**UNITED STATES
NUCLEAR REGULATORY COMMISSION
ADVISORY COMMITTEE ON REACTOR SAFEGUARDS
WASHINGTON, DC 20555 - 0001**

SUBJECT: CERTIFICATION OF THE OFFICIAL TRANSCRIPT OF
THE MEETING OF THE SUBCOMMITTEE ON
RADIATION PROTECTION AND NUCLEAR MATERIALS
HELD ON SEPTEMBER 23, 2011

Title: Advisory Committee on Reactor Safeguards
Radiation Protection and Nuclear Materials

Date: Friday, September 23, 2011

Conceptual Diagram of Enhanced Diagram of Current FCOP FCOP

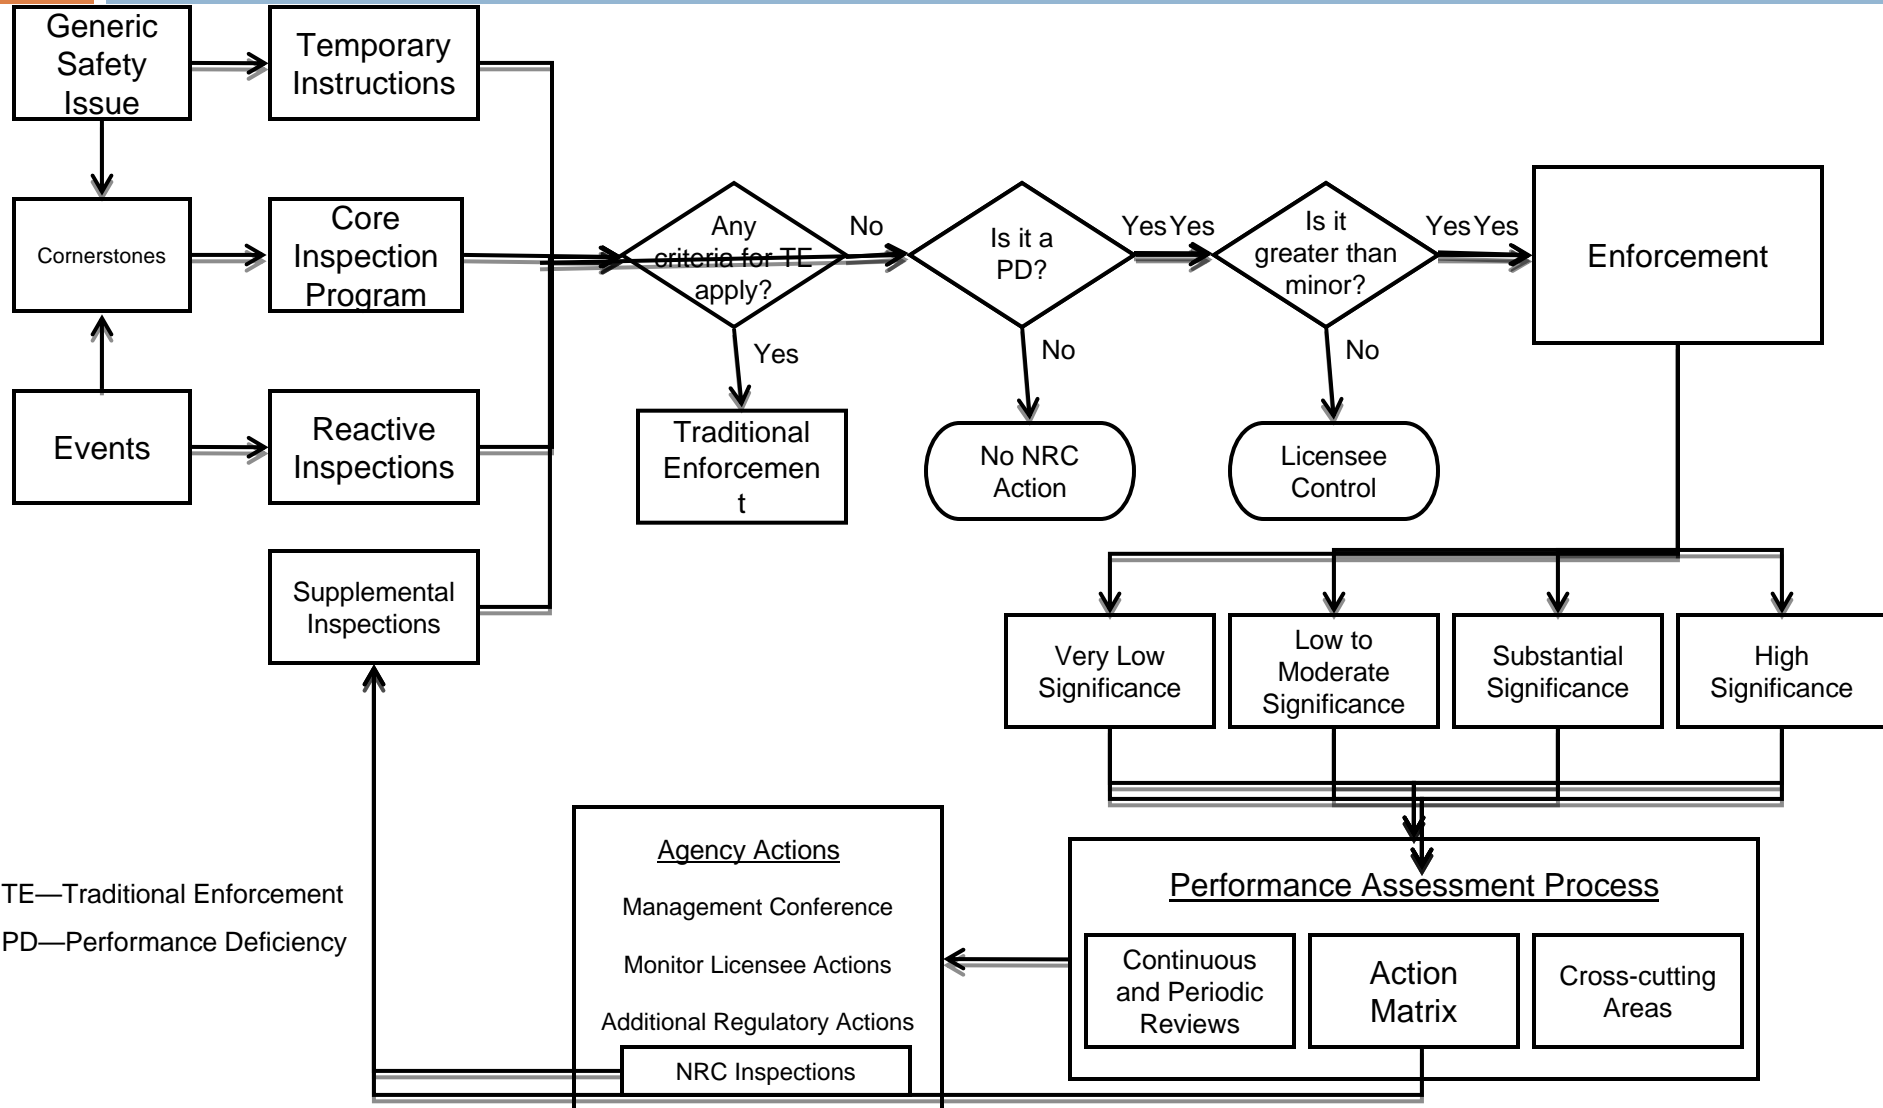
16 DR. FLACK: Yes, a question. On the
17 comparing the two diagrams, one being the proposed
18 versus the traditional, I guess the one that's
19 currently in place now, you mentioned like that first
20 box where it says "Criteria for Traditional
21 enforcement." And you mentioned three things, I
22 guess: Safety significance, the impact of the
23 regulatory process and willful negligence I guess on
24 the part of the licensee. How was that treated
25 before? It looked like the first question you asked

3 DR. FLACK: Okay. So that's the major
4 change there, right there? Right. Yes.

10 DR. FLACK: Oh, one other question. About
11 the crosscutting areas, I know it's a box there but
12 has that been thought out how that integrates into the
13 action matrix. I mean, how would that be taken into
14 consideration?
